## Architectural Review Board

### ARB-40-2018 Certificate of Appropriateness

**Certificate of Appropriateness for a modification to the approved streetscape and new signage for the Market & Main Apartments located at 195 and 200 West Main Street  
(PID: 222-004889, 222-002978).**

### VILLAGE CENTER RESIDENTIAL BUILDINGS "A" AND "E" CERTIFICATE OF APPROPRIATENESS STREETSCAPE & SIGNAGE

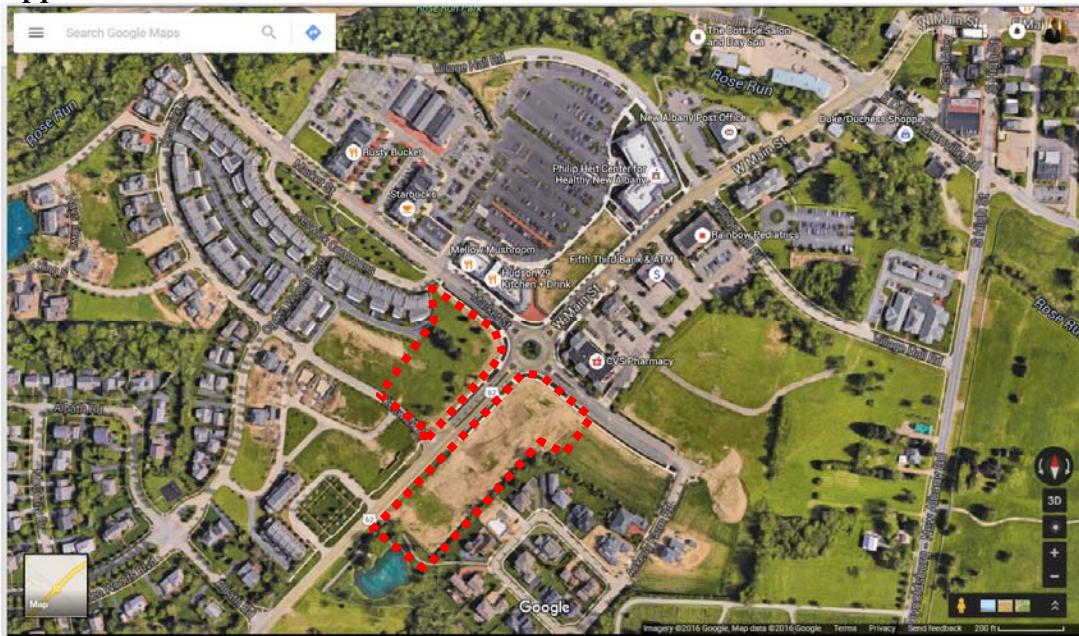
- Streetscape
    - a. The applicant is proposing to change the streetscape treatment along Main Street and Market Street to match the treatment of the Keswick units along Market Street. This will include a turf tree lawn and street trees installed 30 feet on center.

- b. The streetscape treatment was approved to match the treatment at the Market and Main II Site. The proposed streetscape plan would maintain the existing condition within the right-of-way on both side of Main Street

and the south side of Market Street. See graphic below:

- c. The proposed changes will keep the same road design standard, but will modify the tree lawn to be soft-scape instead of the approved hardscape depicted in the graphic.
